Office Action Summary

10/552,246

BRUUN ET AL.

DETAILED ACTION

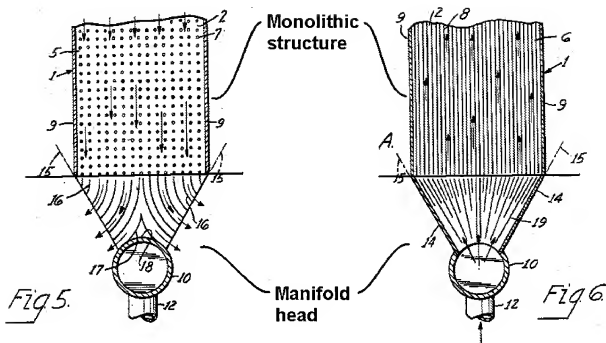
Claims 28, 38 and 43-44 are rejected under 35 U.S.C. 102(b) as being anticipated by Holm. Figures 5-6 (marked up, next page) discloses a manifold system comprising a multi-channel monolithic structure including outer structure walls 3, 4, 9 and inner structure walls 2 defining a plurality of channels 5, 6 spread over an entire cross-sectional area (Figure 4); a manifold head including a first tunnel 10 (Figure 6) and a second entry/exit point (Figure 5, along planes 15) distributing two fluids separately into and out of the channels 5, 6, wherein the first tunnel 10 includes a wall 18 (Figures 1-2) having through slots communicating with first gaps in the manifold head, wherein the second entry/exit point includes a second wall along planes 15 (Figures 1-2) having through slots communicating with second gaps in the manifold head, and wherein at least one of the inner channel walls 2 is common between the first and second fluids (i.e. channels 5, 6).

Regarding claim 38, Figures 5-6 (marked up, next page) discloses the manifold head is fluidly “sealed” to at least one face of the monolithic structure where the channel openings are located.

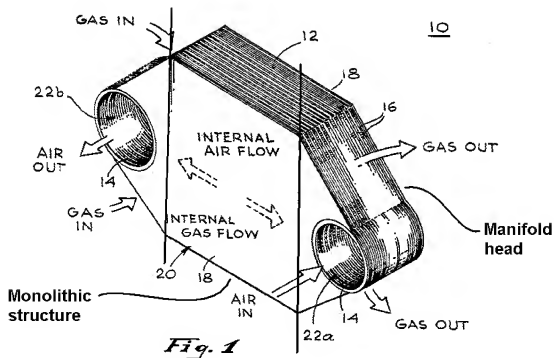
Claims 28, 38 and 43-44 are rejected under 35 U.S.C. 102(b) as being anticipated by Morse. Figure 1 (marked up, below) discloses a manifold system comprising a multi-channel monolithic structure including outer structure walls 18, 42 (Figure 8) and inner structure walls 12 defining a plurality of channels with fins 14, 16 spread over an entire cross-sectional area; a manifold head including a first tunnel 22a and a second entry/exit point (Gas Out arrows) distributing two fluids separately into and out of the channels, wherein the first tunnel 22a includes a wall 50 having through slots (at transition 63 (Figure 6) communicating with first gaps in the manifold head, wherein the second entry/exit point includes a second wall along angled planes (Figures 1-2 and 4) having through slots communicating with second gaps in the manifold head, and wherein at least one of the inner channel walls 12 is common between the first and second fluids (Figure 8).

Regarding claim 38, Figure 1 (marked up, previous page) discloses the manifold head is fluidly “sealed” to at least one face of the monolithic structure where the channel openings are located.
